Petition Number: Insert Zoning Petition #2021-285

General Location Identifier: 12105618

From: Jake Carpenter, PE Reviewer: Walta Blackmon, PE

Date	Description	
05-18-2022	First Review (WB)

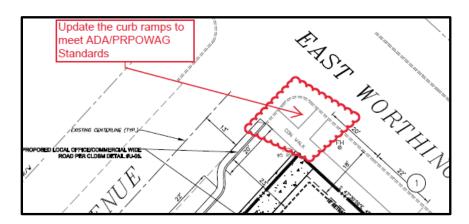
- 1. **Curbline:** The proposed zoning district has a setback measured from back of the existing or proposed future curbline.
  - a. Cleveland Avenue: The future curb and gutter shall be located 20.5-ft from the centerline. This offset represents a Local Commercial Wide Typical section with on-street parking along the site's frontage.
  - b. **East Worthington Avenue:** The future curb and gutter shall be located at 20.5-ft from the centerline. This offset represents a Local Commercial Wide Typical section with on-street parking along the site's frontage. No relocation of the Curb & Gutter is required on East Worthington due to existing mature trees; however, plans must label and dimension the future location.

Label and dimension the curb and gutter from the centerline for each road on the site plan.

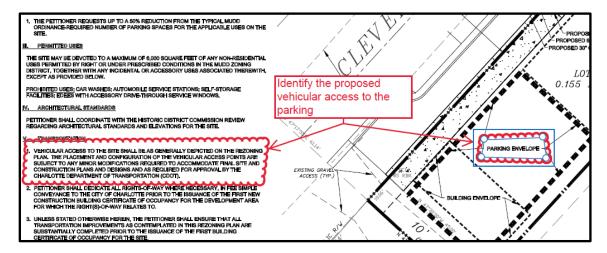
- 3. Revise site plan and conditional notes to label and dimension the East Worthington Avenue right-ofway from the road centerline. The site plan shall label and dimension the right-of-way from the road centerline.
- 4. Revise site plan and conditional notes to label a 2-ft sidewalk utility easement (SUE) 2-ft behind the future back of sidewalk for Cleveland Avenue and East Worthington Avenue (50.5-ft from the centerline).
- 5. Revise site plan and conditional notes to commit to installing ADA compliant curb ramps at the Cleveland Avenue and East Worthington Avenue intersection.
